**RE: SEMIANNUAL PROGRESS REPORT ON CHROMIUM PLUME CONTROL INTERIM MEASURE PERFORMANCE,
JANUARY THROUGH JUNE 2021
LOS ALAMOS NATIONAL LABORATORY
EPA ID#NM0890010515
HWB-LANL-21-056**

Re: Notice of Disapproval

**Semiannual Progress Report on Chromium Plume Control Interim Measure Performance
January through June 2020
Los Alamos National Laboratory
EPA ID#NM0890010515
HWB-LANL-20-080**

ATTACHMENT 2
PLOT OF CHROMIUM CONCENTRATIONS AND WATER LEVELS WITH
INTERIM MEASURES INJECTION OPERATIONS AT REGIONAL AQUIFER
MONITORING WELL R-45

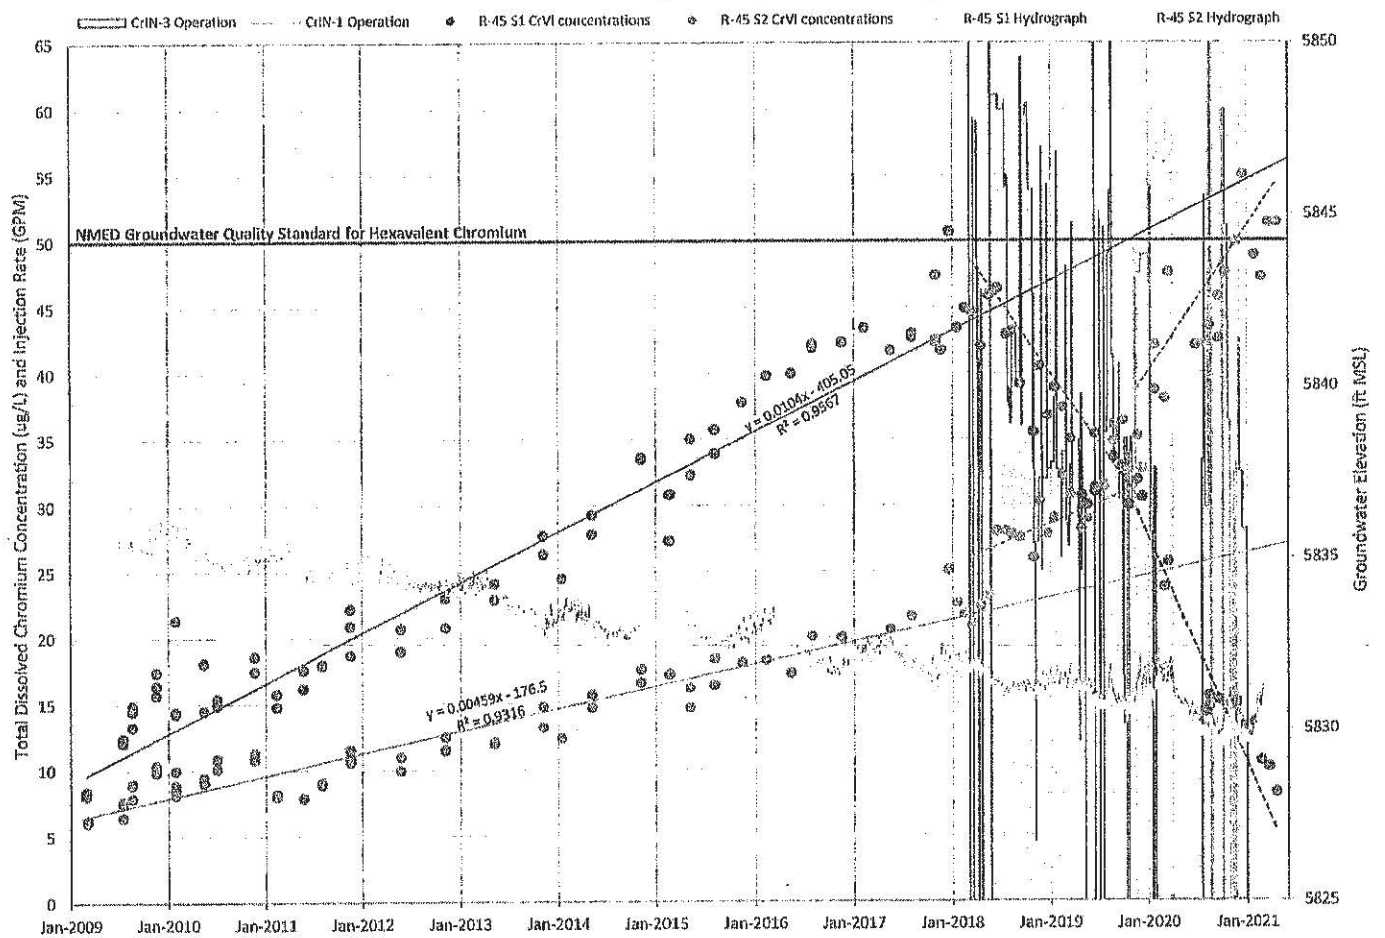
The initial chromium concentration trends at R-45 S2 suddenly surged once CrIN-3 injection began on May 23, 2018, and then again immediately following CrIN-1 and CrIN-2 injection on November 13, 2019, to a point where chromium now exceeds the 50 ug/L NMED groundwater standard (Attachment 2). The initial trend indicates this should not have occurred until 2035. This assertion is supported by the opposite response in chromium concentration at R-45 S1. DOE's exclusion of NMED in the IM planning and reporting has resulted in the deterioration of IM monitoring quality, effectiveness, and purpose since NMED approved the work plan in December 2019⁷. Of specific concern to NMED is DOE's inability to monitor and capture the chromium it has pushed down to R-45 S2 because there are no IM infrastructure wells completed at that depth. To rectify this, DOE must implement NMED's modifications to the continued operation and reporting of the IM including submitting numerical modeling scenario runs to evaluate extraction capture zones and injection flood zones (see General Comment No. 1 above). Cessation of all injection operations should take place over a semi-annual monitoring period at a minimum to evaluate whether the trends recorded at R-45 reverse.

ATTACHMENT 3
CHROMIUM MASS RECOVERY

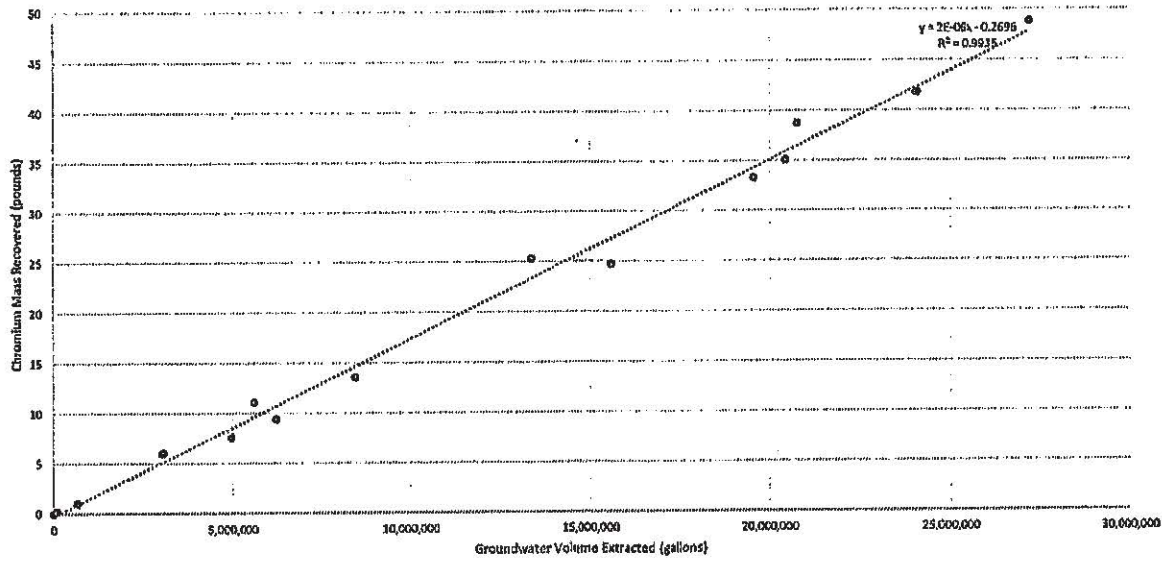
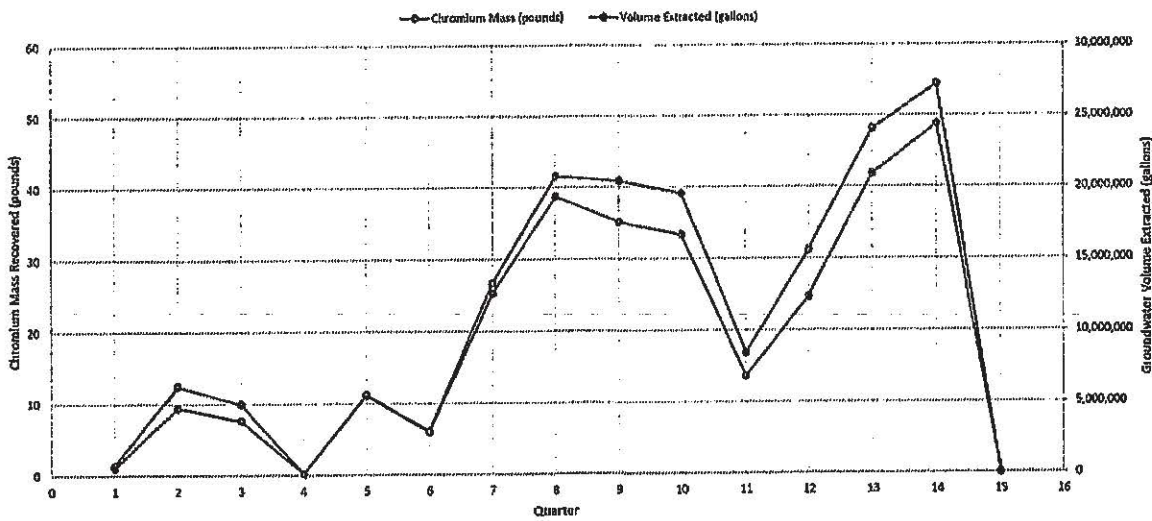
NMED does not concur with DOE's statement *"that the decreasing Cr concentration trends in the extraction wells also reflect a removal of Cr at a faster rate than it is being replenished by upgradient sources"*. The Report indicates only 296.6 pounds of chromium mass have been removed from 169,991,100 gallons of groundwater extracted since the fourth quarter of 2016. The plots in Attachment 3 positively show that the chromium mass recovery rate is directly proportional to the volume extracted, that the recovery rate has not increased but is quite linear, and that the source has had nothing to do with the reported recovery rates. It is more likely that over time, the extraction wells are pulling clean water from storage outside the plume and from the IM injection operations as the radius of influence increases. This would dilute the chromium concentration at the point of recovery. A revised model run should have been used to verify this statement before its inclusion in the Report. DOE must include such a model run to demonstrate the validity of their statement that chromium mass recovery is occurring at a faster rate than the upgradient source can provide or remove the statement from the revision. It should be noted that chromium concentration increases with depth at CrEX-4 and R-70 and the recovery wells do not fully penetrate the chromium plume. Additionally, with the effective removal of the two monitoring wells that formerly monitored the highest chromium concentrations presumably near the source(s) from the groundwater monitoring plan, the source areas are no longer being monitored.
